UNITED STATES ENVIRONMENTAL PROTECTION AGENCY

> RE: Bayou aux Carpes Clean Water Act Section 404(c) Final Determination Request for Exception 3 Consistency Determination (Bayou aux Carpes Augmentation Project)

Environmental Protection Agency Technical Analysis of Proposed US Army Corps of Engineers, New Orleans District Bayou aux Carpes Augmentation Project Removal of Jefferson Parish Plug in Bayou aux Carpes Waterway

Conditions and Best Management Practices for the Proposed US Army Corps of Engineers, New Orleans District Bayou aux Carpes Augmentation Project Removal of Jefferson Parish Plug in Bayou aux Carpes Waterway

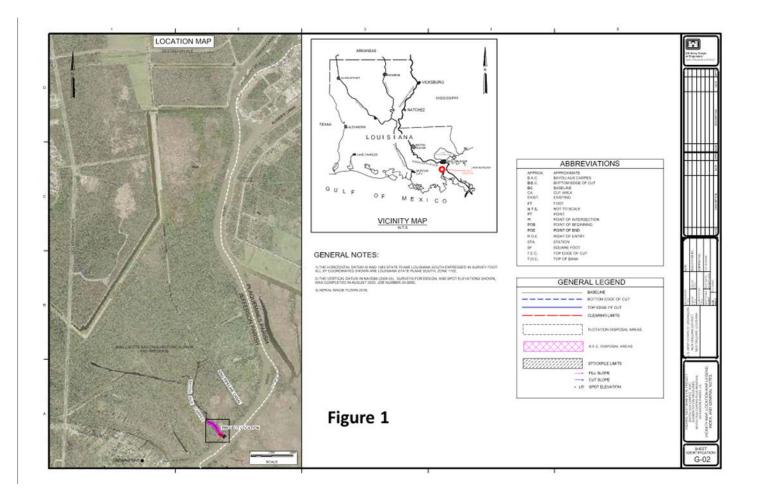
To address the Corps' 2009 modification commitment to provide a habitat-benefit project to Bayou aux Carpes, the District proposed to enhance the hydrology, fisheries habitat, and aquatic organism access in the site by restoring a more natural connection between Bayou aux Carpes and Bayou Barataria. (Figure 1). The District's proposed plan would involve clearing, excavation of the Jefferson Parish plug, and disposal of excavated material. The site work would encompass an area of approximately 2.5 acres; in total, approximately 3,000 cubic yards of material would be excavated and deposited on both sides of the Bayou aux Carpes waterway from the mouth of Bayou aux Carpes at Bayou Barataria upstream approximately 1500 feet. (Figure 2).

The District conducted hydrodynamic modeling on the effects of removing the Jefferson Parish plug. This modeling demonstrated that removing the plug at the historic confluence of the Bayou aux Carpes natural waterway with Bayou Barataria would increase sheet flow through the area's wetlands and improve drainage, thereby benefiting the existing swamps and marshes found within the Bayou aux Carpes site, as well as benefitting fishery and aquatic organism access into Bayou aux Carpes.

After reviewing the District's proposed project, EPA has determined that the work associated with the proposed project will satisfy Exception 3 of the 1985 Bayou aux Carpes CWA Section 404(c) FD. The sole purpose of the District's proposed project is to enhance the hydrology, fisheries habitat, and aquatic organism access in the site by restoring a more natural connection between Bayou aux Carpes and Bayou Barataria, thereby benefitting the restoration and maintenance of the integrity of the ecological and biological processes of Bayou aux Carpes aquatic resources. EPA approves the proposed discharges provided that such discharges comply with the conditions and best management practices identified in Enclosure 2 consistent with the District's proposal. Furthermore, it is the responsibility of the District to obtain all necessary federal, state, and/or local authorizations and conducting all required regulatory coordination and approvals prior to implementing the proposed project.

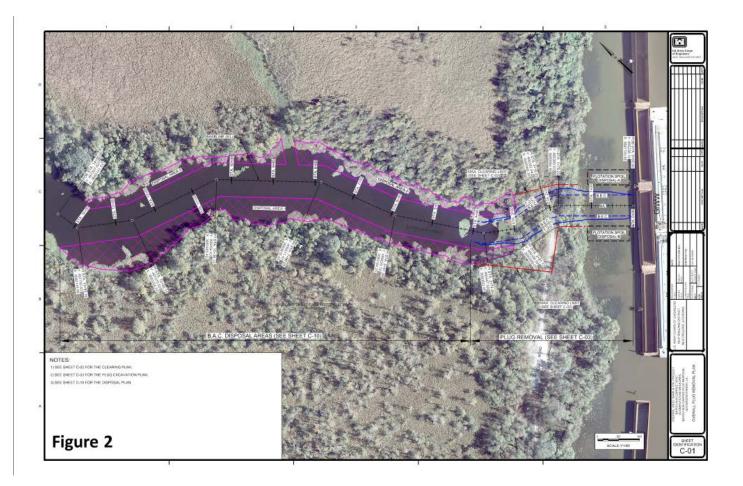
Additionally, any excavated plug material deposited on either side of the Bayou aux Carpes waterway, as depicted in Figure 2, would create shallow water habitat. This shallow water habitat could be used as a spawning and nursery habitat for many fish species and other aquatic organisms.

The District proposes to remove the Jefferson Parish plug, restoring the natural connection of Bayou aux Carpes to Bayou Barataria, and place the excavated material from the plug along a portion of the Bayou aux Carpes waterway to create shallow water habitat. A barge-mounted excavator would remove the plug from the Bayou Barataria side. Plug material will either be stored on the barge until the barge can break through to the Bayou side or be placed temporarily on the adjacent ridge/levee. The excavated plug material will then be used beneficially to create improved shallow water habitat inside of Bayou aux Carpes. This plan has been closely coordinated with the Interagency Environmental Team (IET) and has been received favorably. The IET is comprised of federal representatives from the New Orleans Corps District, National Park Service (NPS), US Fish and Wildlife Service, and EPA, as well as representatives from state partners.

- 1. The US Army Corps of Engineers, New Orleans District (District) must confirm in writing with any contractors conducting work as a part of this project the boundaries of the project worksite, per District proposal, so as to prevent unapproved impacts to adjacent wetlands through unauthorized machinery/equipment access or unapproved discharges of dredged or fill material. Discharges of dredged or fill material are restricted to those areas specified in the project proposal.
